# City of Columbus

## Standard Drawings

Summary of 2007 Revisions – 12 Sheets

## Summary of 2007 Revisions

STD DWG  
2030

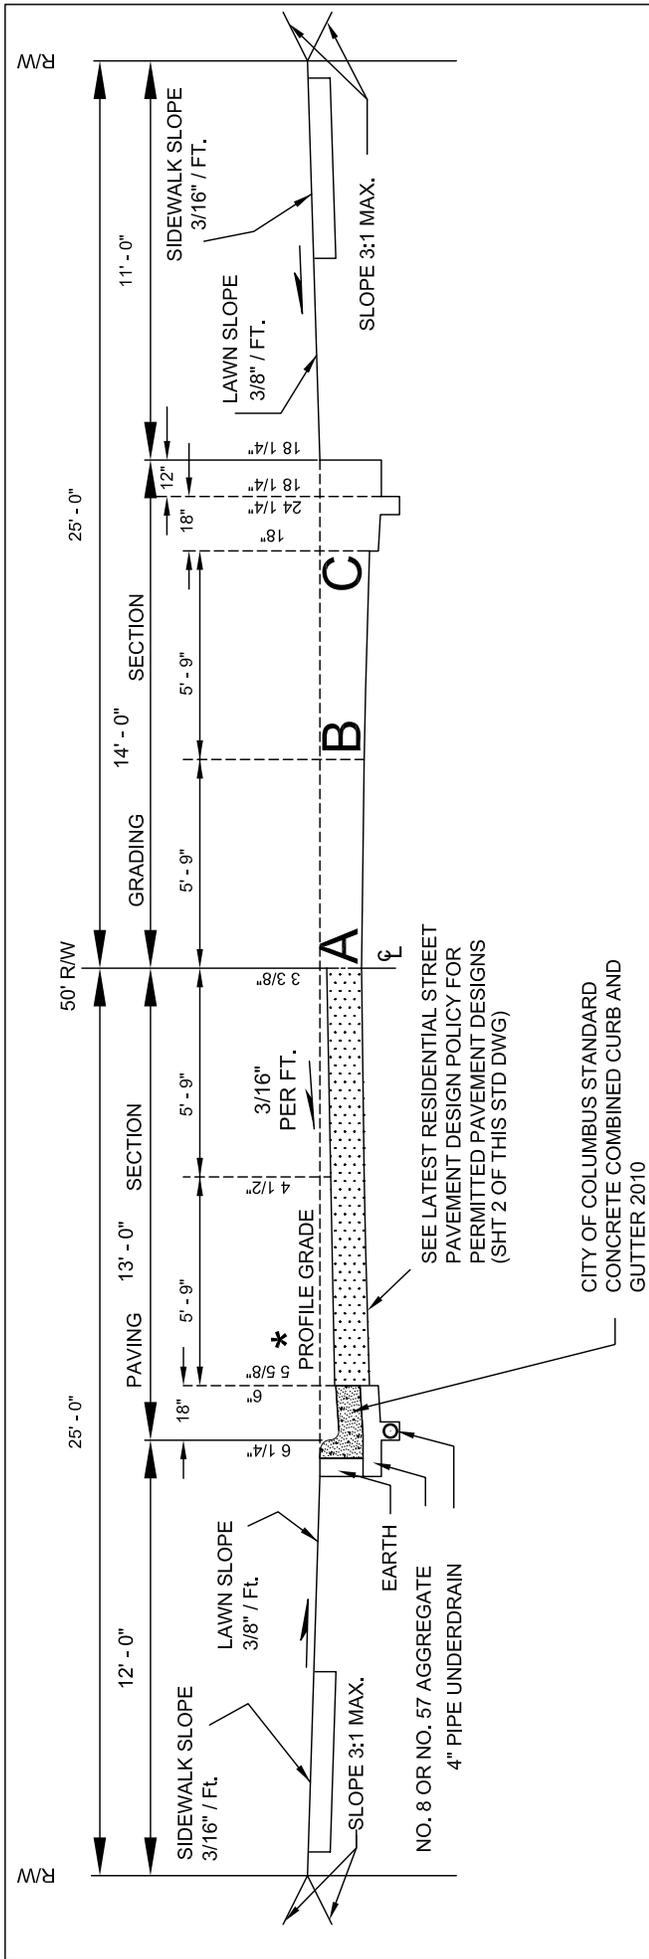
**2030 – New Drawing – Concrete Mountable Curb & Gutter**

Added a new standard drawing for a “Mountable Curb & Gutter”.

<h2 style="margin: 0;">44' SECTION WITH SPECIAL 8" CONCRETE COMBINED CURB &amp; GUTTER</h2>	
CITY OF COLUMBUS, OHIO DEPARTMENT OF PUBLIC SERVICE TRANSPORTATION DIVISION	<b>STD DWG</b>  <b>2120</b>
 CITY ENGINEER	REV: 01/01/07  SHT 1 OF 1

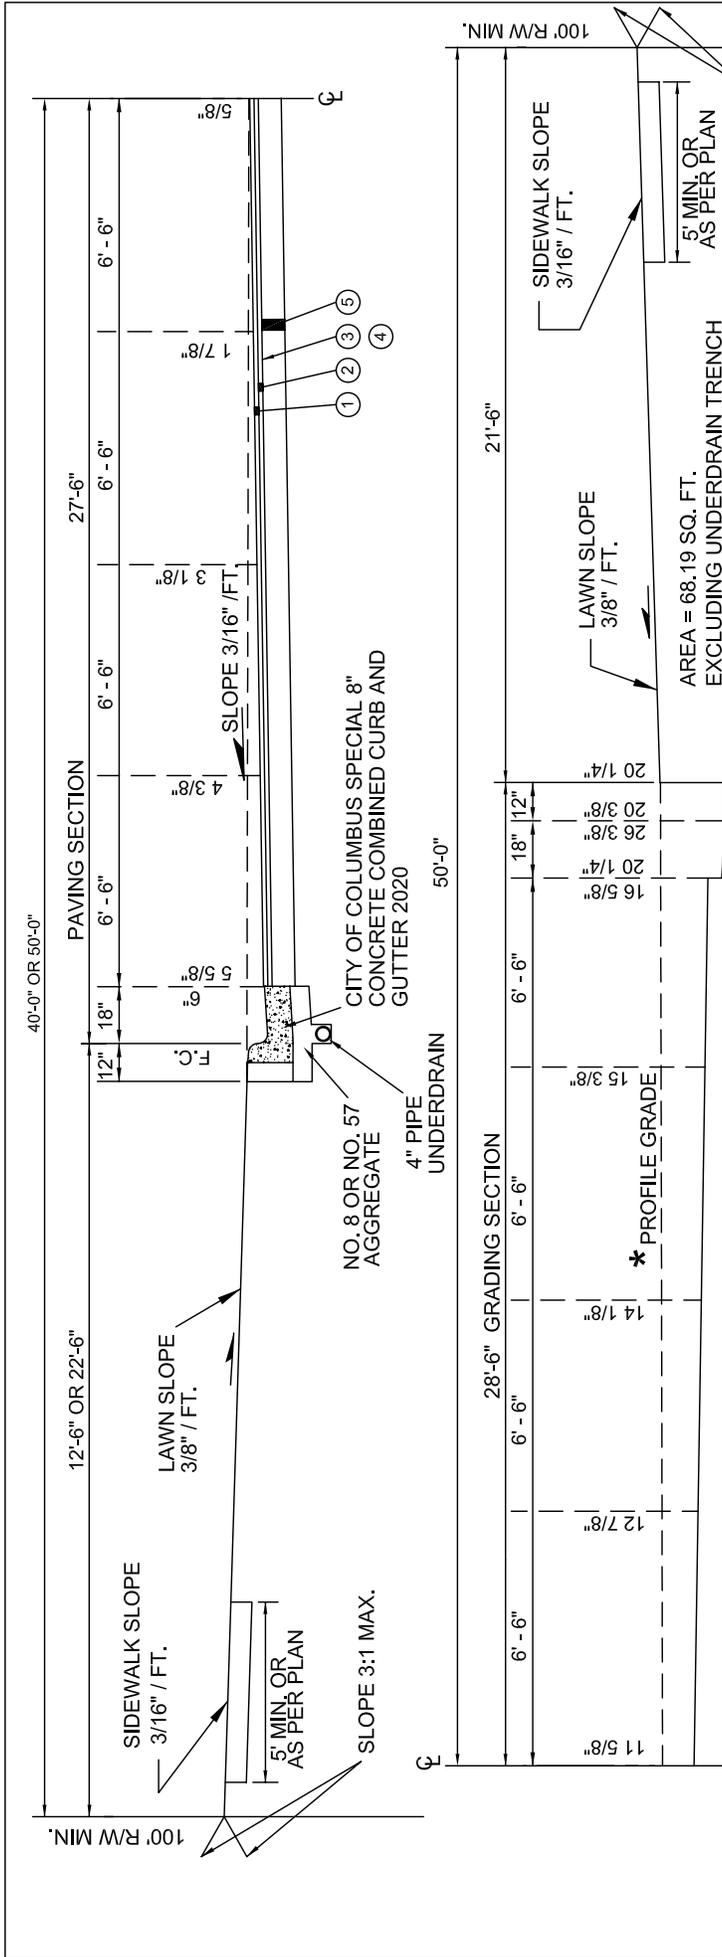
Changed the cut dimensions for accuracy. In the area explanation note deleted the word "below". Replaced 2% with 1.56%. Added an asterisk to profile grade label and added this asterisk note to the sheet "For a special 8" curb and gutter the profile grade and the string line elevation are the same". Added 416 asphalt concrete for an option to 402 or 404. Added 8" into the title.

## TYPICAL ALLEY PAVING SECTION ITEM 452

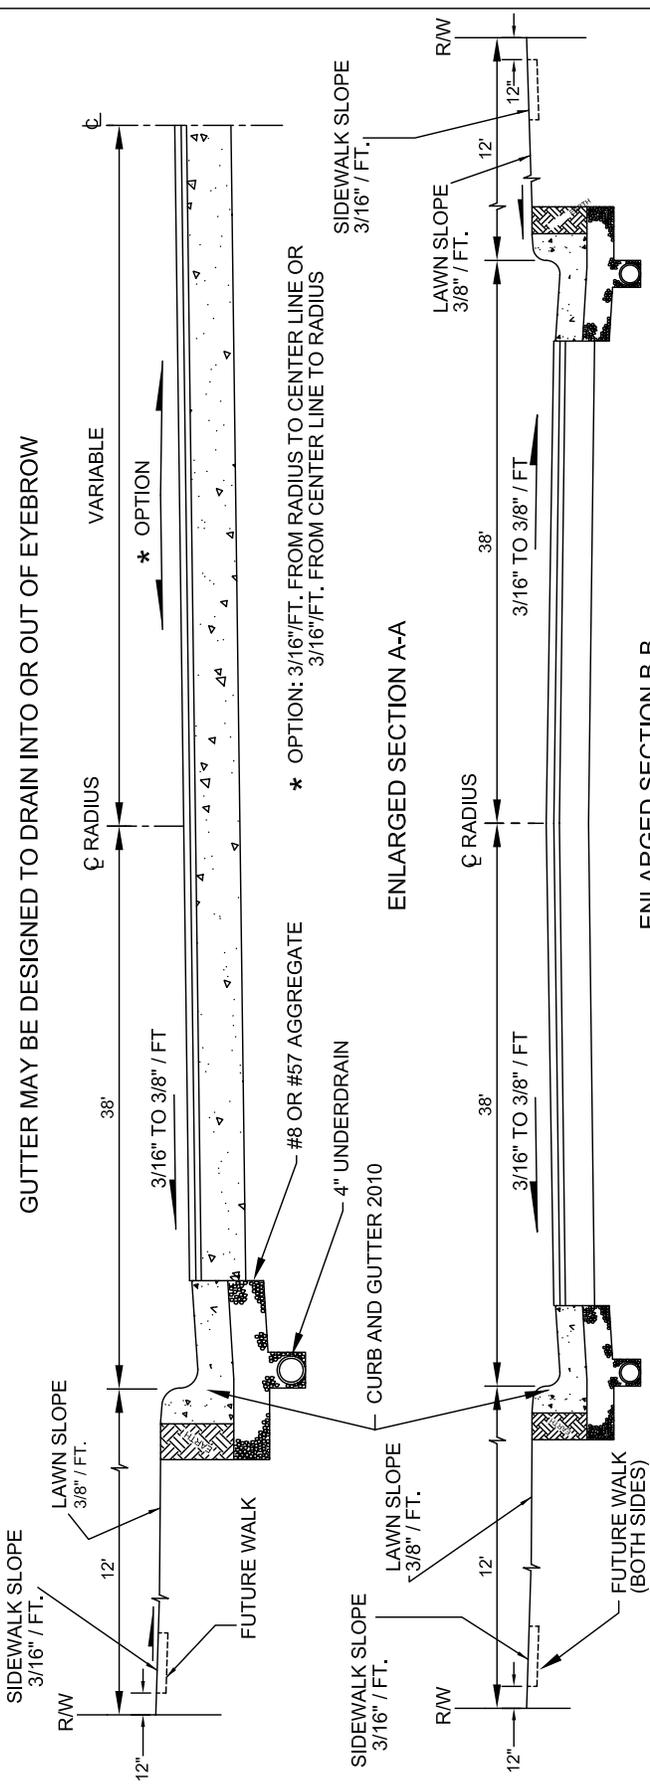
Added a 16’ – 12’ - 2&1/2” alley dimension to the chart. In the bottom line of the chart changed the over 20” to over 24”.

STD DWG  
2191

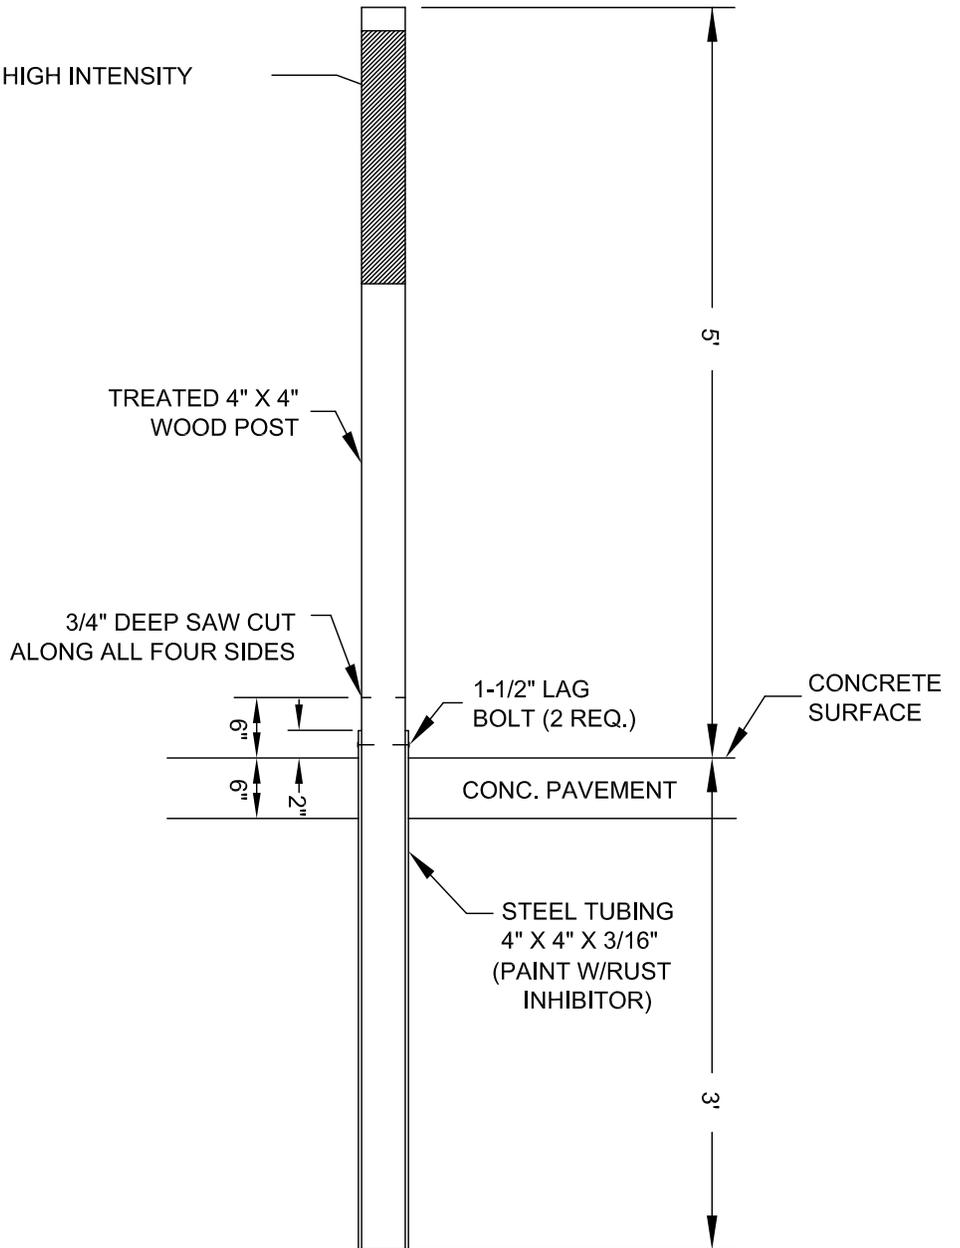
#### **2191 – New Drawing – Typical Drivepost Installation Through Concrete/Asphalt**

This is a new standard drawing to install signposts thru Asphalt or Concrete.

2222

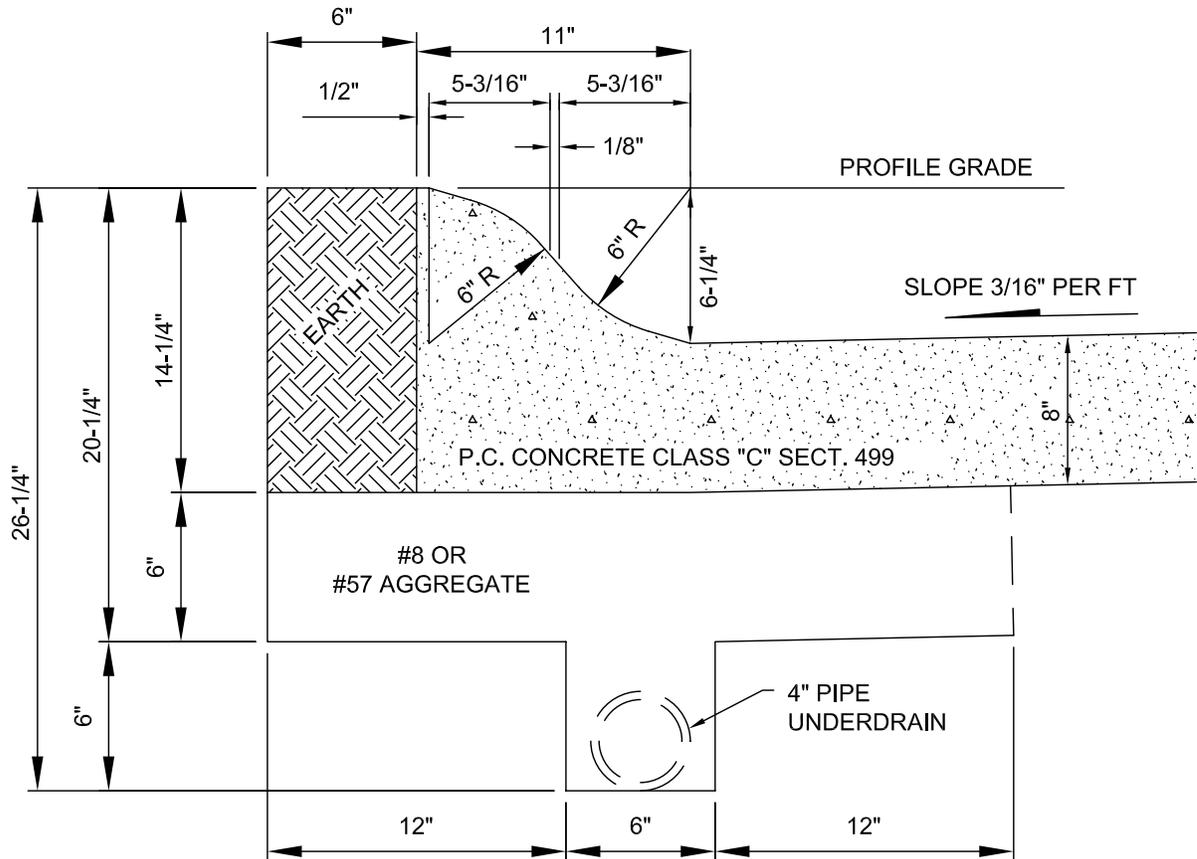
### **2222 – New Drawing - Temporary Construction Entrance**

Added a Standard Drawing for the installation of a construction entrance.

# CURB RAMP GENERAL CONSTRUCTION NOTES

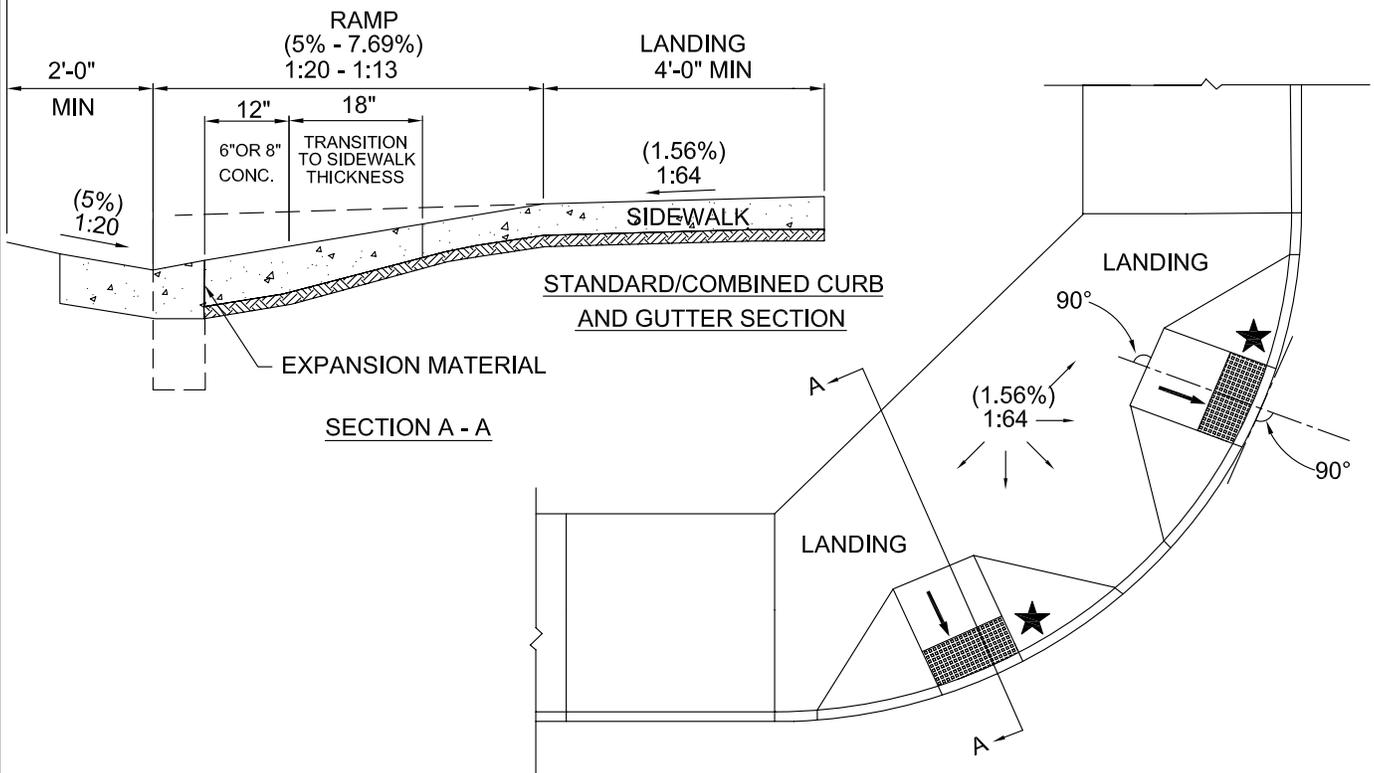
Sheet two – Added, modified, and deleted notes on the General Construction Notes sheet. Added ramps to be installed as per Standard Drawing 2319, 2300, 2303, & Supplemental Specifications 1550, and 1551. Clarified curb ramp components, Noted, concrete material to be used for the curb ramp panel and flares. Deleted Type B, E, K, & P-3 curb ramps. Added note on 8" thick concrete. Deleted the allowance for 3-foot wide curb ramps and made them a minimum of 4 feet wide. Added note on wide flares and one foot flares. Added, top landings to be used "if turning is required". Deleted, note on street landings. Deleted note on directing pedestrians to opposing sidewalk. Modified note on offset intersections. Modified note on cross walks.
